# Access Compliance Report

## Public Rights-of-Way

Intersection ID: 28316	Main Street: KENDERLY_CT	Cross Street: ZACKERY_AV	Location: NW
ADA ID: 61C8308463B0	Ramp Type: BlendTrans2	Initial Pass/Fail: Fail	Overall Compliance: No
		Severity Score: 10

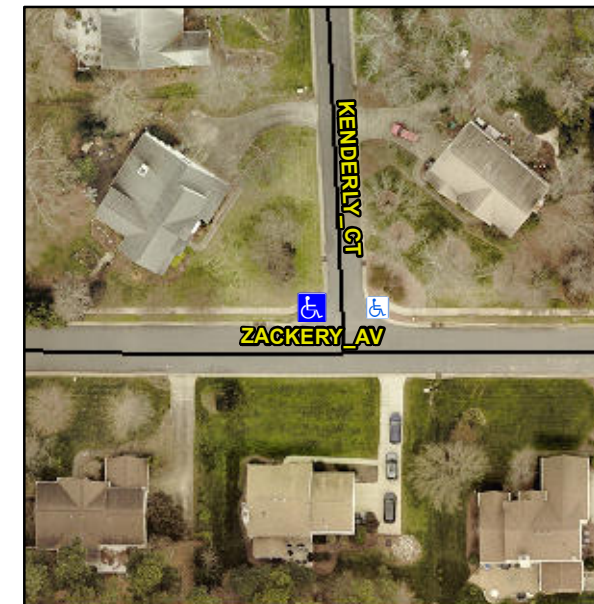
**Not Found, R304.5.1, R304.5.3**

Compliance	Description	Data	Compliance	Description	Data
N/A	Ramp Length (in)	97.0	Yes	BlendTrans Slope (%)	3.8
No	Ramp Width (in)	46.0	No	BlendTrans XSlope (%)	3.5
N/A	Flare Type LT	N/A	N/A	Flare Type RT	N/A
N/A	Flare Slope LT (%)	N/A	N/A	Flare Slope RT (%)	N/A
N/A	Flare Traversable LT?	N/A	N/A	Flare Traversable RT?	N/A
N/A	Landing Length (in)	N/A	N/A	DWS Provided?	N/A
N/A	Landing Width (in)	N/A	N/A	DWS Contrast?	N/A
N/A	Landing Slope (%)	N/A	N/A	DWS Length (in)	N/A
N/A	Landing X Slope (%)	N/A	N/A	DWS Full Width?	N/A
N/A	Landing Curb? (Y/N)	N/A	N/A	DWS Offset (in)	N/A
N/A	Shared Landing?	N/A			
N/A	Gutter Ponding?	N/A	N/A	Gutter Slope (%)	N/A
N/A	Gutter Lip Ht (in)	N/A	N/A	Gutter X Slope (%)	N/A
N/A	Painted X Walk1?	No	N/A	Painted X Walk2?	No
	X Walk 1 Direction	To S		X Walk 2 Direction	To E
	X Walk 1 Width (in)	N/A		X Walk 2 Width (in)	N/A
	X Walk 1 Slope (%)	1.2		X Walk 2 Slope (%)	1.0
	X Walk 1 X Slope (%)	1.9		X Walk 2 X Slope (%)	0.4

N/A	Ramp inside XWalk1?	N/A	N/A	Ramp inside XWalk2?	N/A
	Road Slope (%)	1.9		Clear Space?	N/A
	Road X Slope (%)	4.3	N/A	Clear Space to XWalk (in)	N/A
N/A	Any Obstructions?	N/A	N/A	Storm Grate/Utility Hazard?	N/A
	Obstruction Type			Storm Grate/Utility Type	
		N/A			N/A
			Yes	Surface Condition? (G/P)	Good
			No	Curb Slope (%)	18.1

**Remove & Replace Curb Ramp With Two New Directional Ramps or Equivalent.**
